Problems with door open detection sensor

Description of problem

Shelf with label

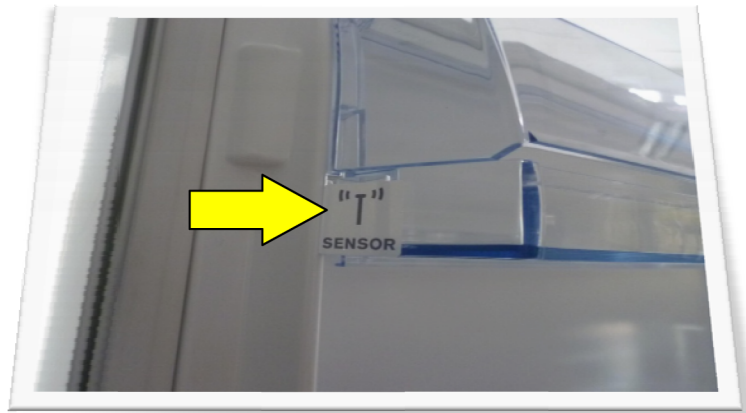
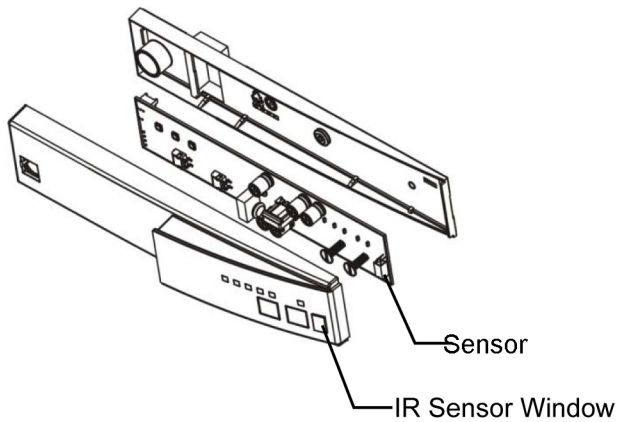
Sometimes in the new models that use an infrared sensor to establish whether the door is open or closed, the sensor fail to identify the door position correctly.

This only occurs when the door opening direction on the appliance is inverted.

To solve this problem, attach a label to the shelf near the sensor.

Label 2620130019
